Planning Committee

Monday, 29th November, 2021, 6.00 pm

4 07/2021/00886/ORM and 07/2021/00887/ORM - Pickering's Farm Site, Flag Lane, Penwortham

Report of the Director of Planning and Development attached.

Figure 1 Currently Observed traffic speed variation A582 NB

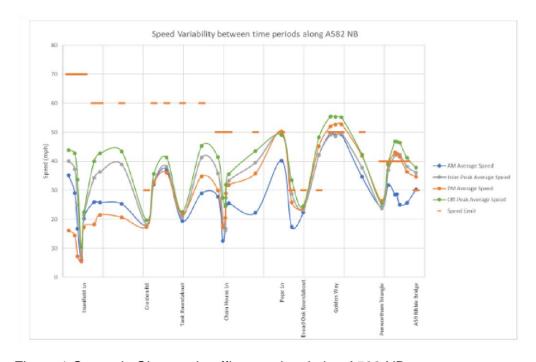
The impact of the A582 junctions on traffic speed is well illustrated in the diagram below which shows recent measured values of traffic speed. This graphic was extracted from the LCC SOBC for the A582 Widening Project Reference 14. The diagram shows the impact on Northbound traffic but the same pattern also exists for the South Bound traffic. Note the classic saw-tooth speed profile, and requirement for multiple acceleration and deceleration cycles. This sawtooth profile generates high levels of pollutants. Also note that the A582 in the vicinity of Stanifield Lane to the M6 is currently dualled and most major junctions have already been upgraded..

as feature 4 on the Illustrative Master Plan. The scheme is also shown in figure 4.12 of Appendix 11.1 and on

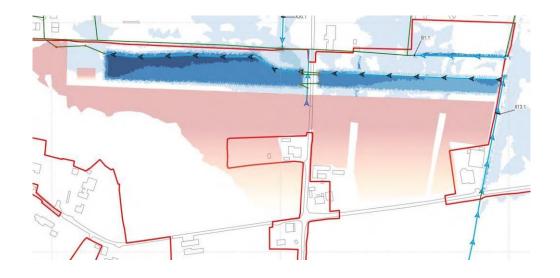
- 2.5 The proposed flood mitigation for catchment B is far more complex because of the site topography and drainage catchment area. It is concluded in the appendix 11.1 that there is insufficient gradient for gravitational flow from an attenuation basin as for catchment A. The approach proposed is to create an artificial flood basin at the north boundary of the site shown

McCloy drawing titled "Proposed Daylighting and Reprofiling" Fig No M01852-01.

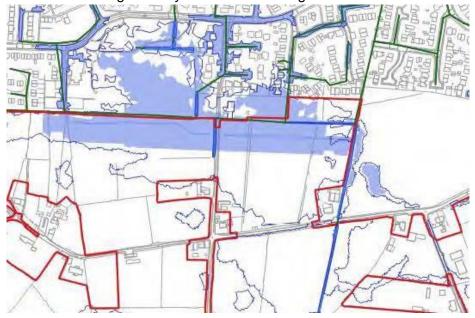
Note this figure given as Fig 4.15 in the Appendix 11.1 shows the flood basin filled and overflowing into Kingsfold in the case of a 1 in 100 year event plus a 40% global warming allowance. Note the raised earthworks to the immediate south of the flood basin "protect" the site at the expense of Kingsfold which has no protective earthworks. Note the diagram does not show the full extent of flooding in Kingsfold; and that the Penwortham Town Council Building appears to be impacted by flooding.

Figure 3-18: Predicted on-Site Flooding (3.3% & 1% AEP)

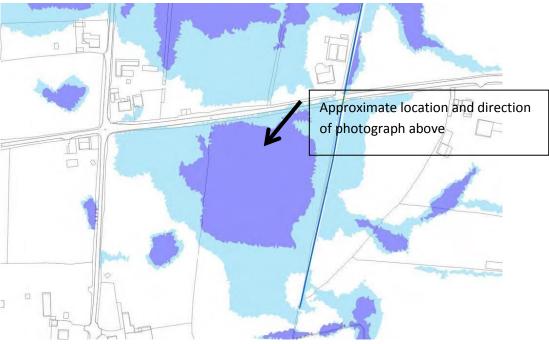
3.1 Appendix 11.1 section 3.10 deals with model validation. In this section the authors argue that pictures of "historic" flooding provided by "objectors" to the scheme in fact help validate the model. The authors imply that the two photos in question are from a one off historic event. By comparing the photos with what is predicted in the model they claim the model then accurately predicts such a "historic" event and proves the model is sound.

Light blue is the 1 in 100 year event (1% AEP) and the dark blue is the 1 in 30 year event (3.3% AEP)

Figure 3-20: Predicted on-Site Flooding (3.3% 1% AEP).

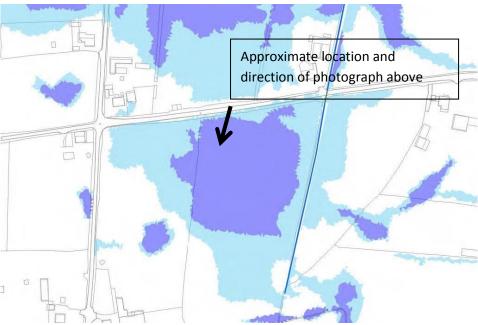
They also use the second photo below to "validate" the model.

shown as feature 4 on the Illustrative Master Plan. The scheme is also shown in figure 4.12 of Appendix 11.1 and on

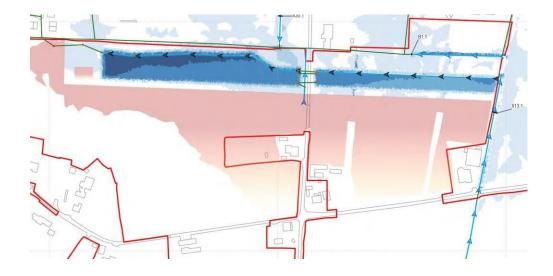
- 2.5 The proposed flood mitigation for catchment B is far more complex because of the site topography and drainage catchment area. It is concluded in the appendix 11.1 that there is insufficient gradient for gravitational flow from an attenuation basin as for catchment A. The approach proposed is to create an artificial flood basin at the north boundary of the site

McCloy drawing titled "Proposed Daylighting and Reprofiling" Fig No M01852-01.

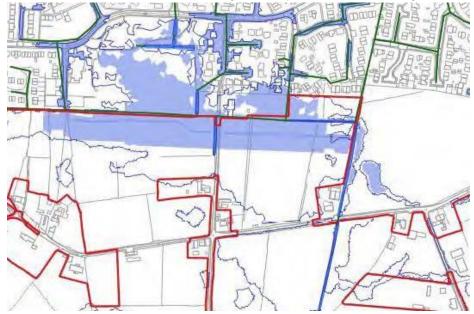
Note this figure given as Fig 4.15 in the Appendix 11.1 shows the flood basin filled and overflowing into Kingsfold in the case of a 1 in 100-year event plus a 40% global warming allowance. Note the raised earthworks to the immediate south of the flood basin "protect" the site at the expense of Kingsfold which has no protective earthworks. Note the diagram does not show the full extent of flooding in Kingsfold; and that the Penwortham Town Council Building appears to be impacted by flooding.

Figure 3-18: Predicted On-Site Flooding (3.3% & 1% AEP)

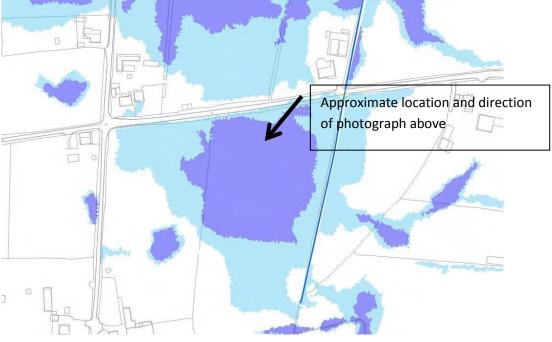
3.1 Appendix 11.1 section 3.10 deals with model validation. In this section the authors argue that pictures of "historic" flooding provided by "objectors" to the scheme in fact help validate the model. The authors imply that the two photos in question are from a one-off historic event. By comparing the photos with what is predicted in the model they claim the model then accurately predicts such a "historic" event and proves the model is sound.

Light blue is the 1 in 100-year event (1% AEP) and the dark blue is the 1 in 30-year event (3.3% AEP)

Figure 3-20: Predicted On-Site Flooding (3.3% 1% AEP).

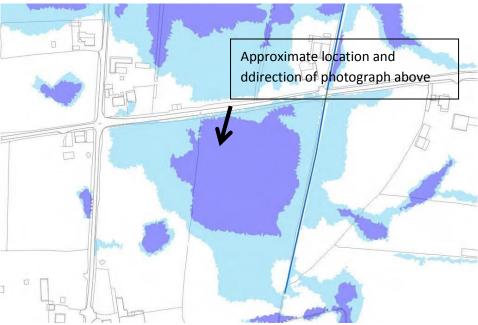
They also use the second photo below to "validate" the model.
